# FOX POINTE

## AN ADDITION TO WICHITA, SEDGWICK COUNTY, KANSAS

FINAL PLAT

Re: Fox Pointe Addition (Final Plat)  
S/D 88-52

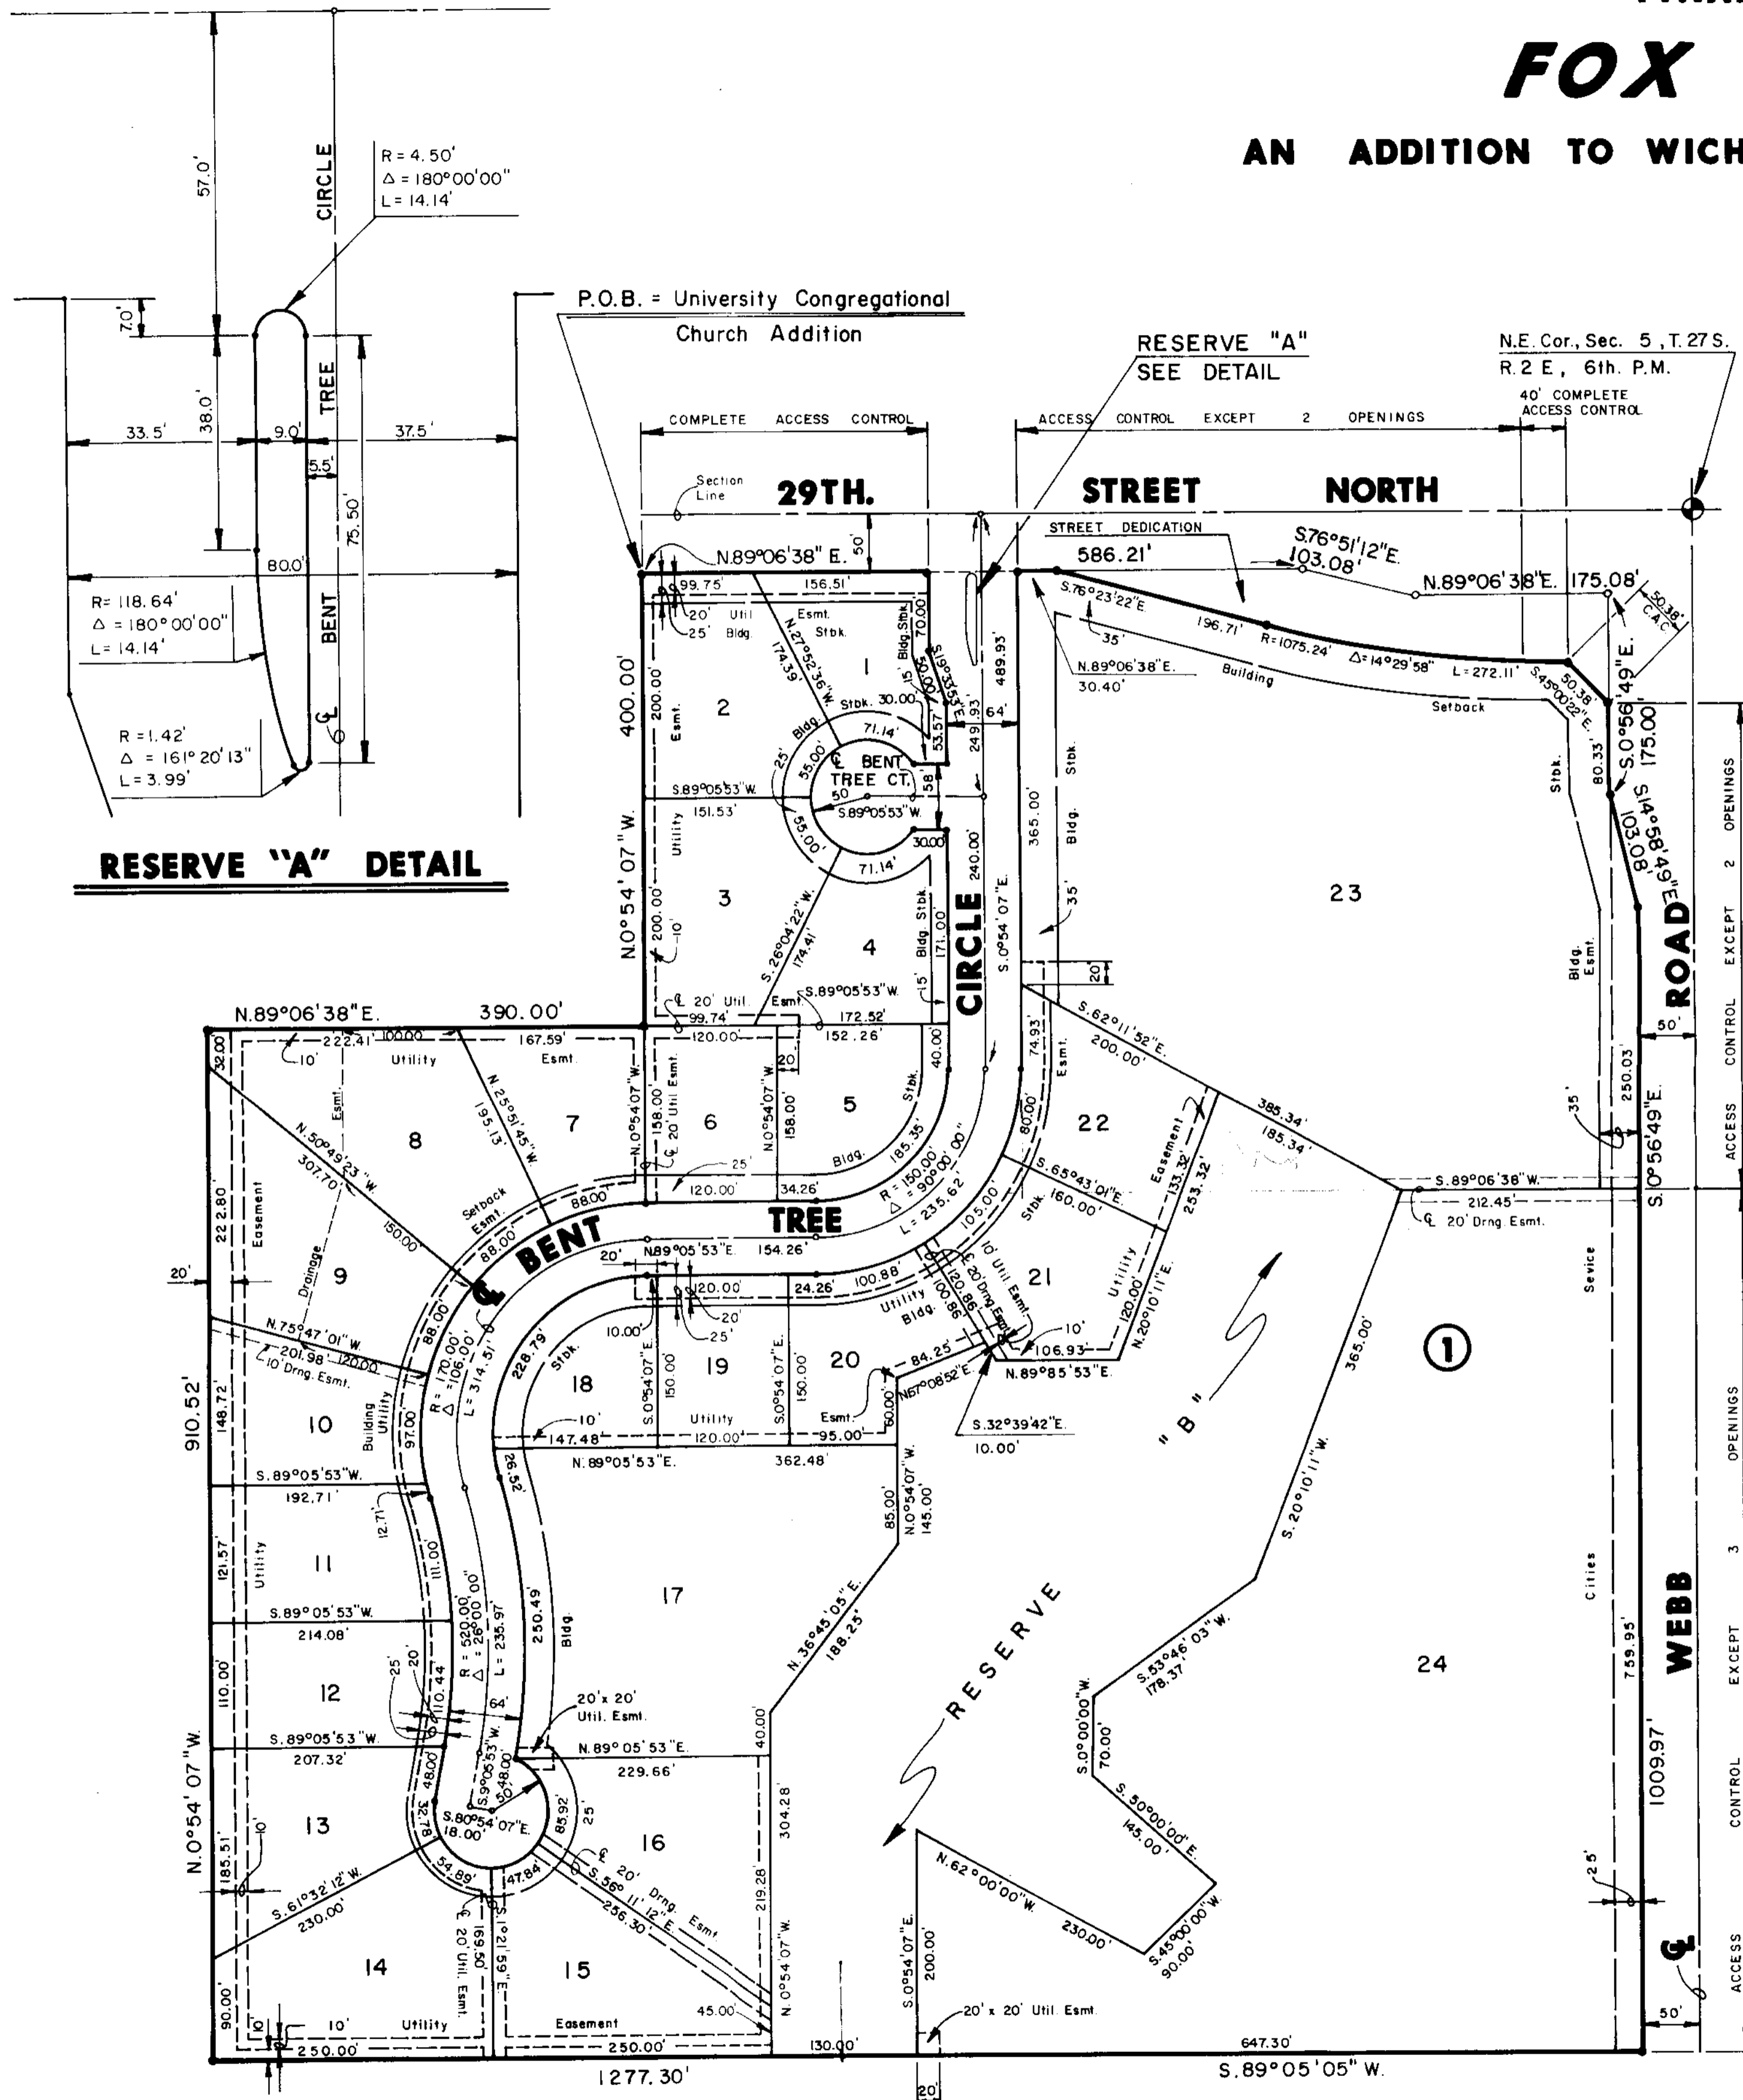
- S. Approval of this plat requires the modification of Section 7-201(R). This portion of the Subdivision Regulations states that the maximum length of a cul-de-sac street shall not exceed 600 feet. Bent Tree Circle, as depicted on the preliminary plat, is approximately 1,400 feet long.

- Y. The representative from the City Engineer's office should be prepared to comment on the applicant's drainage plan. Specifically, is the perimeter of the floodway (Reserve B) correct, what minimum building pad elevation is required, and what drainage guarantees are needed?

- Z. When the preliminary plat was approved, a condition was established for the applicant's agent to meet with the Traffic Engineer regarding the need for accel/decel lanes to serve Lots 23 and 24. The representative from Traffic Engineering should be prepared to state if a guarantee for accel/decel lanes is required with this plat.

- L. On the final plat tracing, the plattor's text shall be amended to state that Reserve B is also being platted as a floodway. This was correctly depicted on the approved preliminary plat.

- M. In order to provide a means of access to Reserve B from a public street, the final plat tracing shall indicate a strip of Reserve B extending to Bent Tree Circle.

- R. As was pointed out when the preliminary plat was approved, it is the applicant's responsibility to be sure the perimeter of Lot 24 does not exceed the configuration of the application area for "BB" zoning. With this in mind, the applicant shall submit a marked print of the plat which depicts the perimeter of the zone change request relative to Lot 24.
